TENNESSEE VALLEY AUTHORITY

SEQUOYAH NUCLEAR PLANT (SQN) - NRC INSPECTION REPORT NOS. 50-327/90-18 AND
50-328/90-18

ENCLOSURE 1

BE-416N-

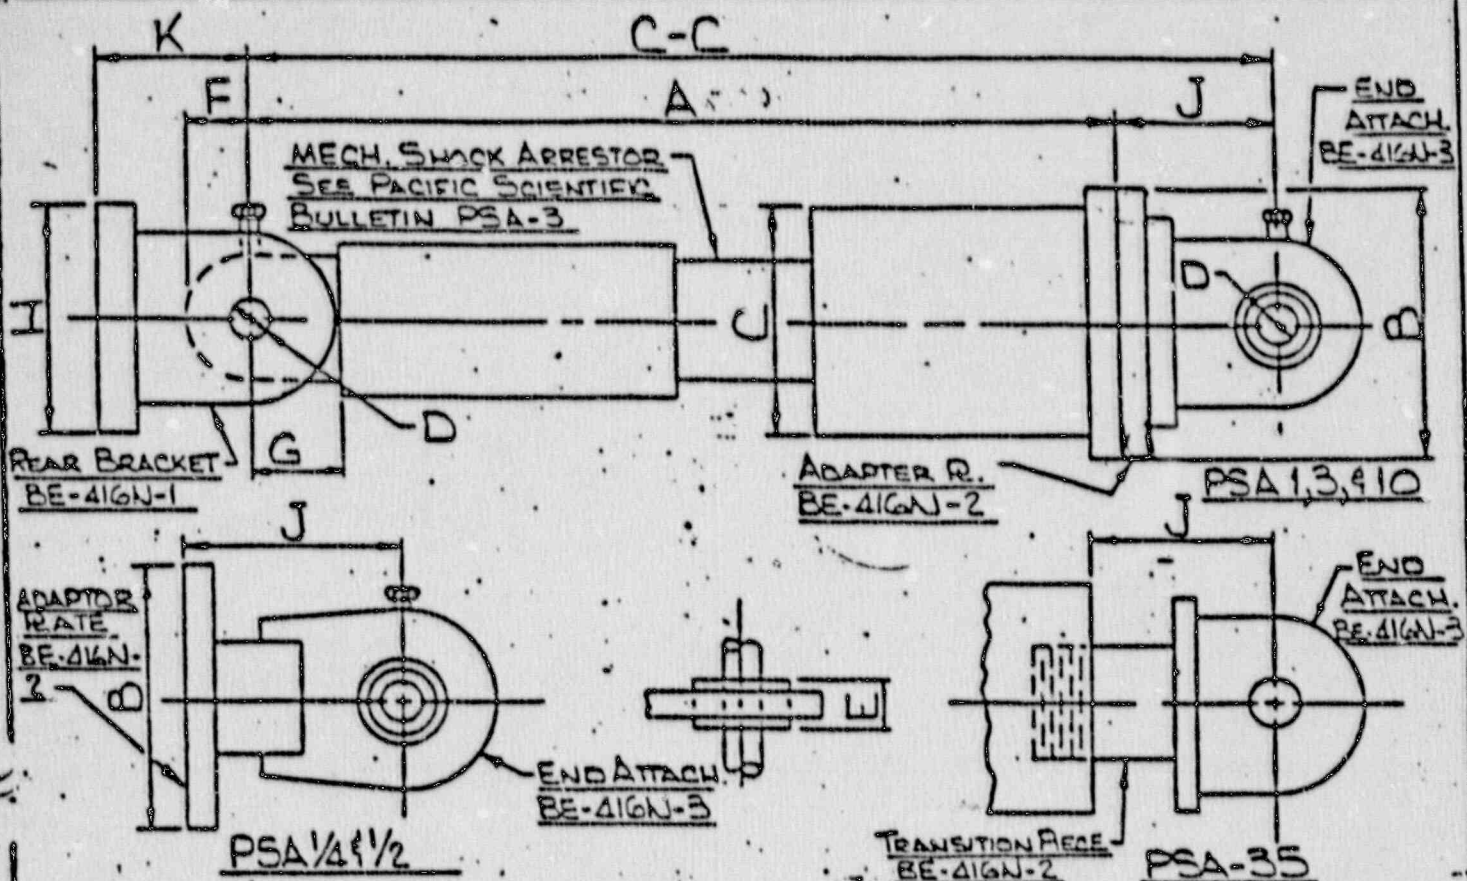
The appropriate vendor-certified load capacity data sheets were used for post-NF mechanical snubbers installed at SQN. Attachment 1 to this enclosure is Vendor Figure BE-416N; it was used by TVA and provides rated loads for NF mechanical snubbers. With the exception of Model Number PSA-1, all allowables are lower than the ASME Section III allowables. The BE-416N allowable for PSA-1 is 2,320 pounds versus the ASME Section III allowable of 2,300 pounds. This difference is less than 1 percent, which is considered insignificant. (Figure BE-416N does not provide a faulted allowable for PSA-100, but there are no safety-related PSA-100 snubbers in Category 1 structures at SQN.)
